**SUNDRY NOTICES AND REPORTS ON WELLS 03 2018**  
*Do not use this form for proposals to drill or to re-enter an abandoned well. Use form 3160-3 (APD) for such proposals.*

RKI EXPLORATION & PRODUCTION RESPECTFULLY REQUESTS TO P&A THE ABOVE MENTIONED WELL.

**Holly Federal #1  
Proposed WB**

Les Peeler 09-12-17  
API No: 30-015-24195

**Proposed Plugged WBD**

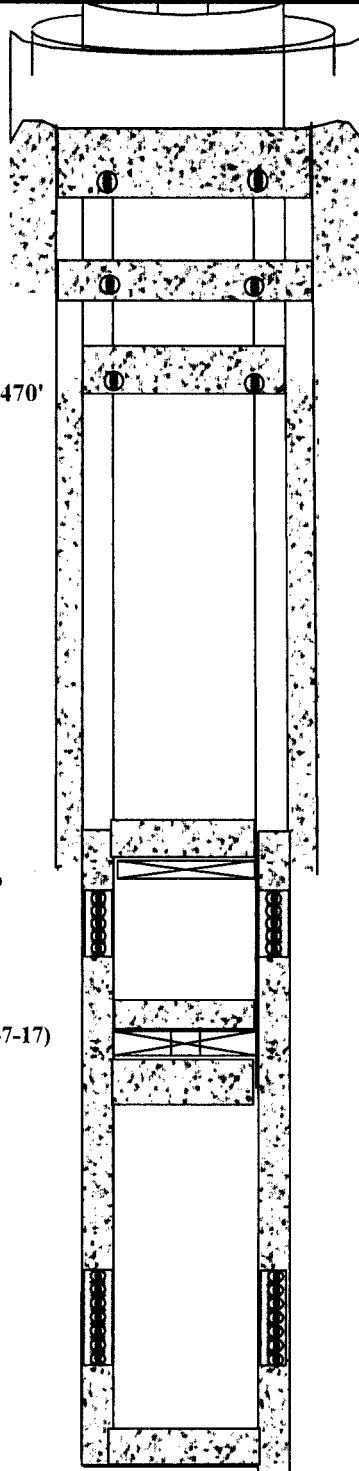
**\*\* BLM REVISED \*\* BLM REVISED \*\* BLM REVISED \*\* BLM REVISED \*\* BLM REVISED \*\***

**Perf @ 150' & Sqz. 60 sxs. to surface**

**Perf @ 428' & Sqz. 60 sxs.**

**Perf @ 620' & Sqz. 60 sxs. WOC-Tag @ 470'**

**Set CIBP @ 2908' & Spot 30 sxs. cmt. on top**

- 3) ND WH, NU 3K# BOP.
- 4) POOH rods & tbg. & Lay Dn.
- 5) MI RU wireline unit. Run <sup>4</sup> 1/2" GR/JB to 2,908'. <sup>2950</sup>
- 6) RIH w- 4 1/2" tbg. conveyed CIBP & set @ <sup>2950</sup> 2,908' - PU 1 jt. Pump 65 bbls. heavy mud. Spot 30 sx Class C Cement (14.8 ppg, 6.3 gps, 1.32 cfs yield) ~~2,908' - 2,600'~~ flush with heavy mud. TOOH w- tbg. <sup>2950-2650</sup>

- 7) RU WL & Perforate 4 holes @ 620'. RD wireline. *Perf w/ deep penetrating shots*  
*both 4 1/2" and 8 5/8"*
- 8) RIH w- Pkr & tbg. - set Pkr - Attempt to establish pump rate. Squeeze 60 sx Class C Cement (14.8 ppg, 6.3 gps, 1.32 cfs yield) from 620' to 470'.

- 9) WOC & Tag @ 470'.
- 10) RU WL - Perf @ 428' - Attempt to establish pump rate. Squeeze 60 sxs. cmt. *Perf both 4 1/2" & 8 5/8"*
- 11) RIH w- Pkr & tbg. - set Pkr - Attempt to establish pump rate. Squeeze 60 sx Class C Cement (14.8 ppg, 6.3 gps, 1.32 cfs yield) @ 428'.

- 12) RU WL - Perf @ 150' -. Squeeze 60 sxs. cmt. to surface, *Perf both 4 1/2" & 8 5/8"*
- 13) RDMO Service Unit. RDMO Cementers.
- 14) MIRU Welder. Cut-off casing head. WO cap with well name and number, operator name, and date.
